23rd March 2024
Surrey County Council
via e-mail
FAO : Charlotte Parker – SCC Planning Support Team

SCC 2023-0045 – Former Brockhurst Care Home Outline Planning Application Revisions - ONF Representations

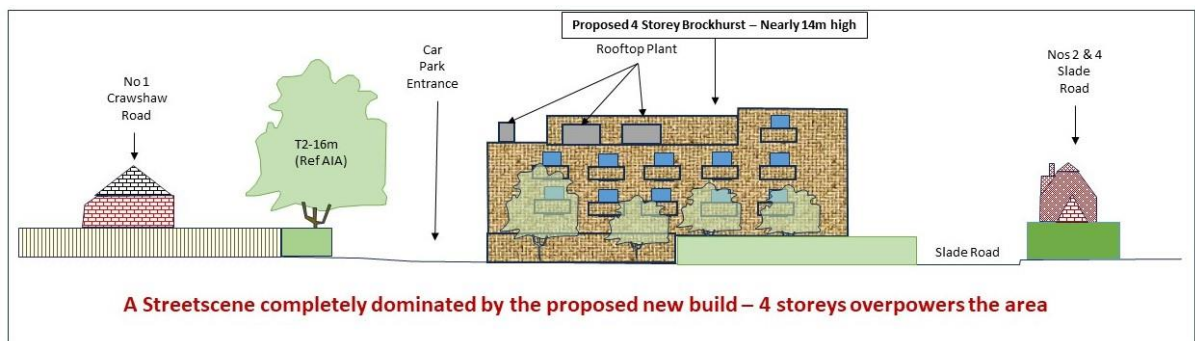
3. We remain **strongly in support** the provision of a C3 Extracare facility within Ottershaw and welcome a number of the amendments from the previous submission which mitigate some issues we had raised, however it is our view that the outline design **still fails to meet the objectives of design and practicality in a number of key areas.**
4. It appears that SCC are determined to increase the capacity of the facility to the detriment of the solution and the surrounding area. In our view this is neither tolerable or practicable at this location remote from the village centre.
5. It is our view that these issues need to be fully addressed before proceeding to full detailed application.

We therefore recommend the proposal is REFUSED subject to resolving the issues indicated below.

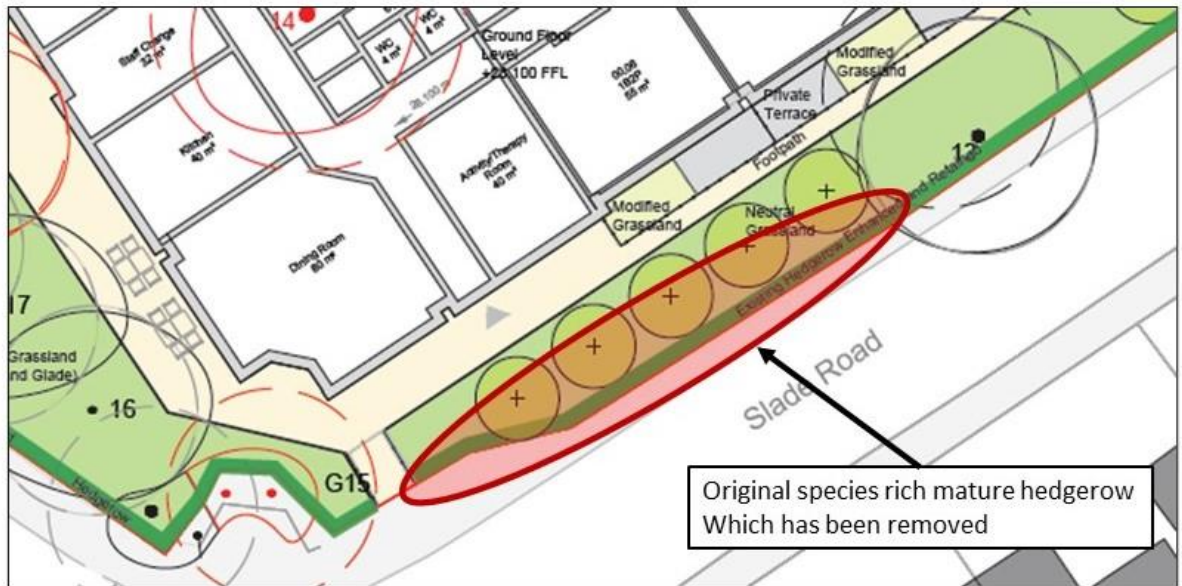
31. We bring the following recently emerging issue to your attention. The recent reoccupation of the brownfield site opposite at 66-72 Brox Road should be considered from a risk perspective. The site is occupied by a hoarding company who have HGV and other vehicles regularly using the site. Whilst the site operates a notification system for the larger vehicles, they park outside nearby and can only enter the site by reversing under supervision. There is therefore a risk that the entrance to the care facility could be blocked and eg prevent access or egress by emergency services.
32. The on road manoeuvres by the HGV vehicles operating from WS Hunts on the opposite corner should also be considered.

33. The operating patterns of the other site need to be comprehended and the entrance design for Brockhurst will need to be sufficient to reduce or remove the risk of

blocking of the entranceway. This may require consideration of widening and/or changing of the sweep angles at the entranceway.
